Information Request

Street Address: 81 Savage Street Cooktown 4895

Application Number: DA/4677

Description of Proposal: Shopping Centre

(a) Example A, Western Boundary on Section 3, Drawing DA08.

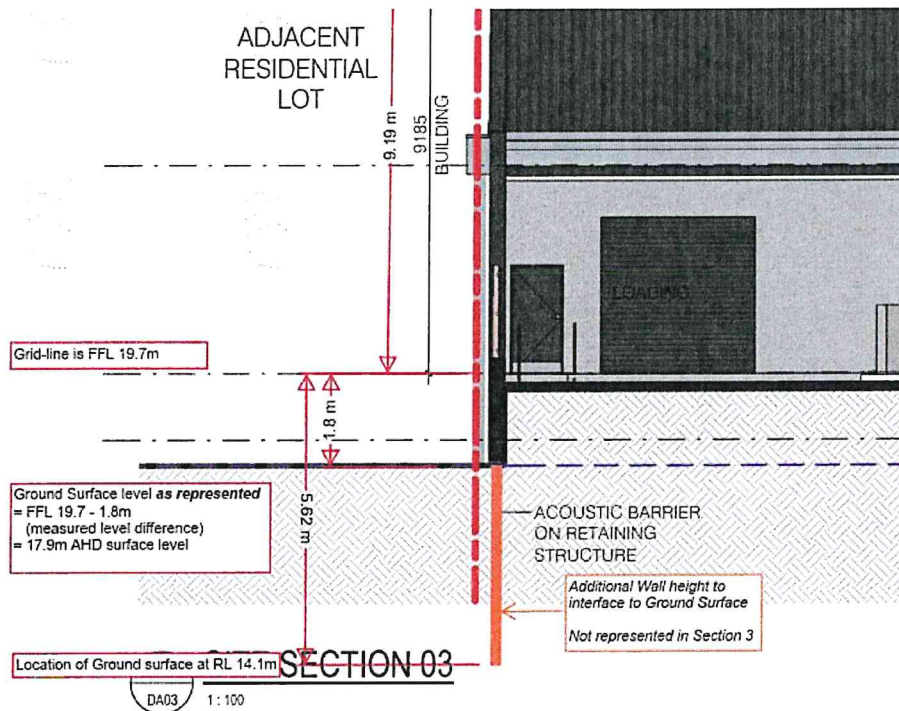
Section 3 on Drawing DA08 does not appear to represent the natural surface and resulting level difference correctly (refer extract below).

The existing surface is represented as being only 1.8m below the FFL line of 19.7m. That is, the natural surface level at the Lot boundary on drawing DA08 Section 3 is measured as approximately RL17.9m.

However, the spot level shown on drawing DA03 near Section 3 is nominated as RL14.1. This represents a difference of approximately 2.8m between the represented surface and the actual surface.

- 13. Provide revised drawings that address the apparent discrepancies with the existing ground surface level shown on the elevations and sections. The updated detail must also correct the building height line shown and ensure that the plans accurately represent the height above the existing ground level.**

(b) Example B, Northwest Corner of Site.

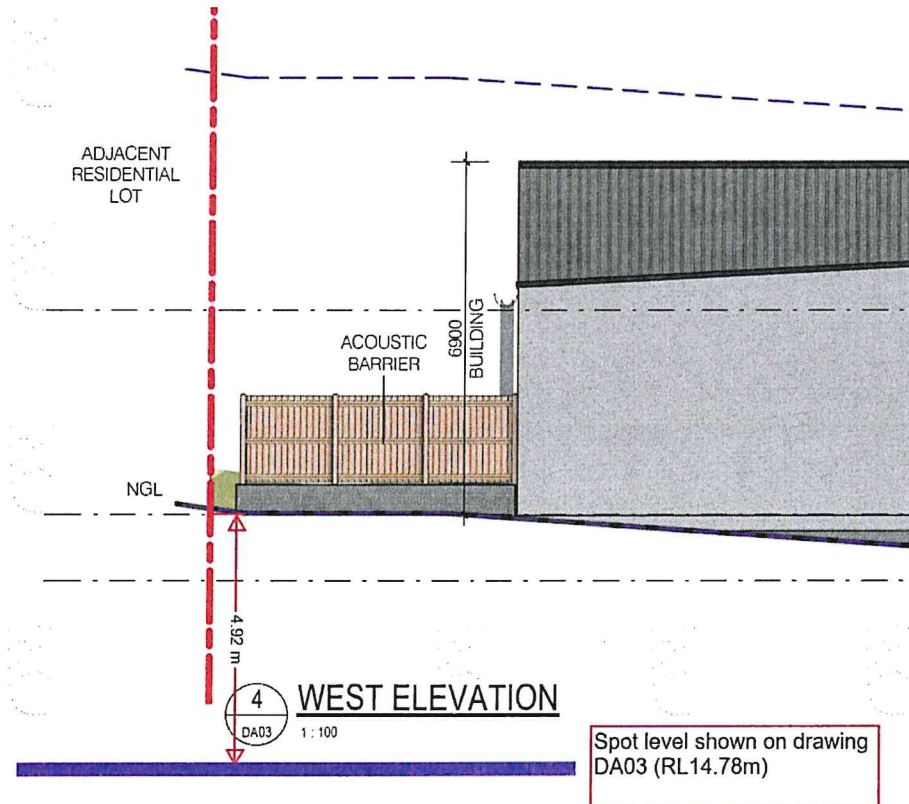
The spot level shown on drawing DA03 at the corner of northern and western Lot boundaries is RL14.78. This level has been verified against the site contours in the Bulk Earthworks design.

However, there is an inconsistency between this level and the existing surface level (and profile) represented in the West Elevation shown on drawing DA07.

The existing surface level at the Lot boundary on drawing DA07 West Elevation section is shown to be coincident with or above the level of the FFL for the building, RL19.7m.

Given the building has minimal setback to the western boundary, the west elevation should reflect the levels along the western boundary. The spot level of RL14.78, verified from the Bulk Earthworks design, represents a difference of almost 5m from the existing ground level shown.

It appears that the long sections on drawing DA08 and DA07 do not present the natural surfaces at the western Lot boundary and the interface between design levels and natural surface levels correctly.

- 14. A plan is required that clearly and accurately depicts the works required at the interface of the western boundary. Provide dimensioned plans including the offsets between Lot boundaries and proposed retaining walls, and the top and bottom wall heights proposed for retaining walls. This is a key consideration in determining the potential impacts of the development on the adjoining residential amenity.**
